Technical Service Bulletin

SUBJECT:		No: TSB-21-54-004	
UPDATES TO CHASSIS ELECTRICAL - SERVICE MANUAL REVISION		DATE: October 2021	
		MODEL: See Below	
CIRCULATE TO:	<input type="checkbox"/> GENERAL MANAGER	<input checked="" type="checkbox"/> PARTS MANAGER	<input checked="" type="checkbox"/> TECHNICIAN
<input checked="" type="checkbox"/> SERVICE ADVISOR	<input checked="" type="checkbox"/> SERVICE MANAGER	<input checked="" type="checkbox"/> WARRANTY PROCESSOR	<input type="checkbox"/> SALES MANAGER

This TSB provides updated content for the Chassis Electrical section of the affected Service Manuals, Horn.

HORN

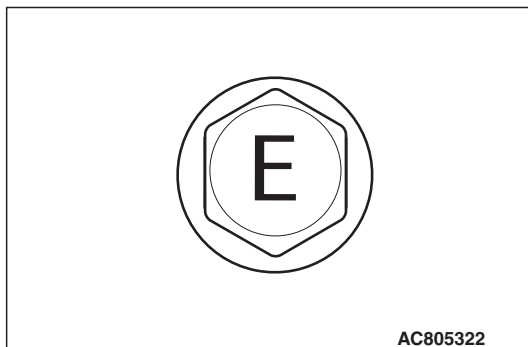
>>A<< 1. Horn (LOW)

>>A<< HORN (LOW) INSTALLATION

Use the ground bolts as the mounting bolts for horn (LOW).
The ground bolts have "E" mark on the bolt heads.
